AMENDMENT TO THE DRAWINGS

FLASHLIGHT AND COMBINATION FOR USE IN
ALIGNING FLASHLIGHT LAMP BULBS
INV: A. MAGLICA
DKT: 728256-100/119
ANNOTATED SHEET SHOWING CHANGES

Fig. 3

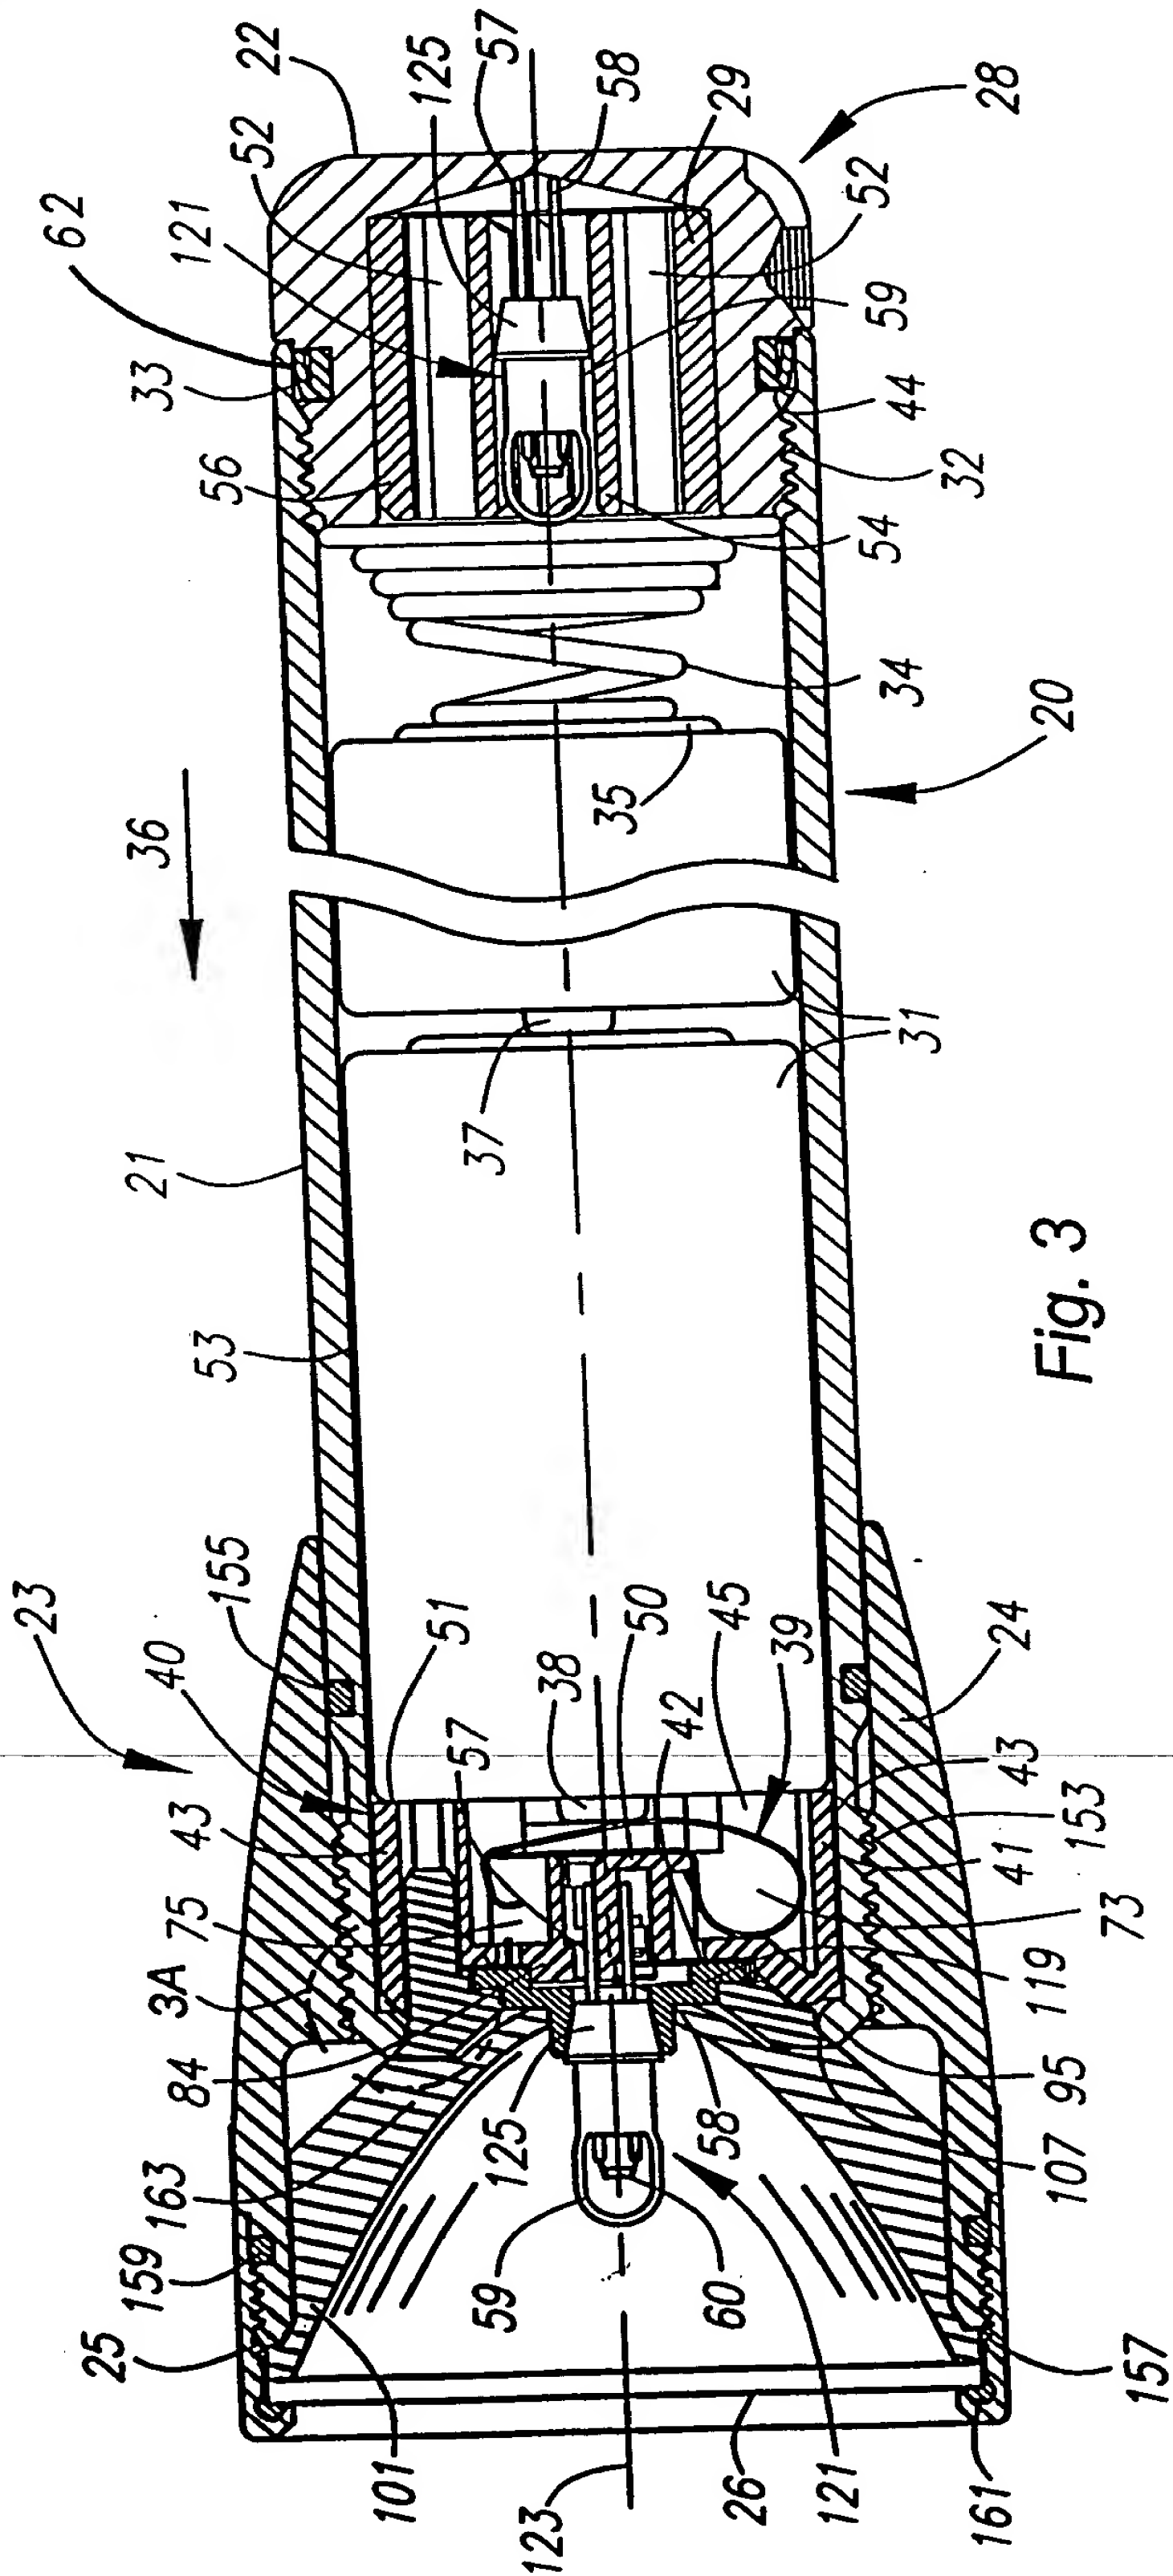
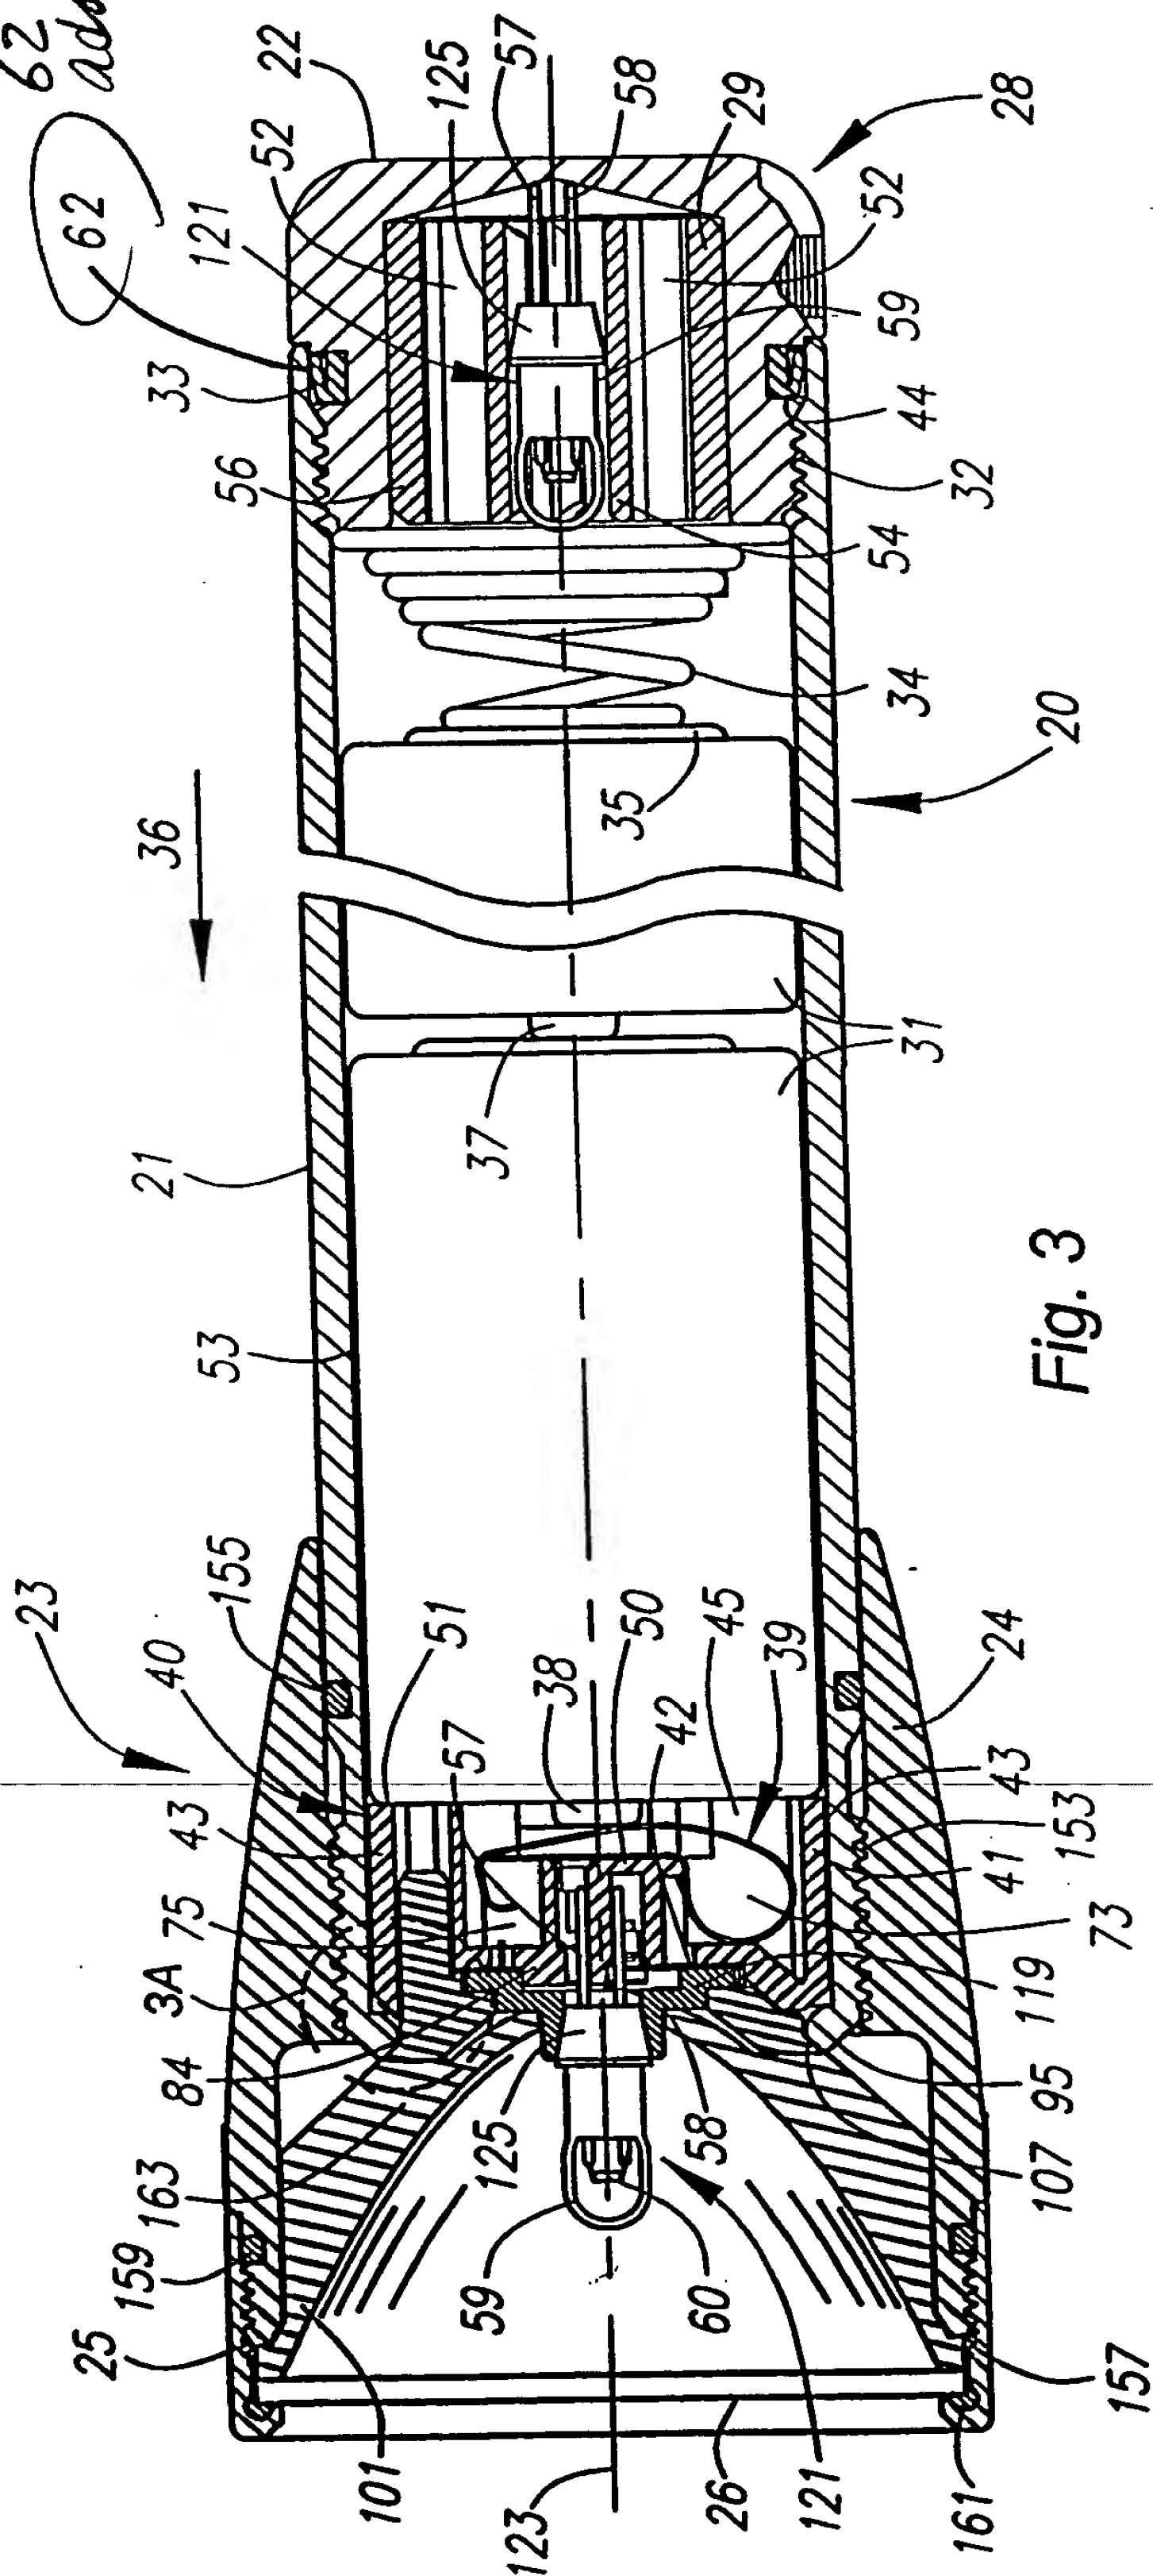
Replacement sheets 02/06, 03/06 and 04/06 replaces original sheets of drawings having the same sheet number. In each of amended Figs. 3, 5 and 6, a new element number character 62 is added to identify the "one way valve" that is disclosed in the body of the specification. The support for this amendment can be found in the specification, for example, at paragraph numbers [0041]. Therefore, no new matter has been added.

62 address
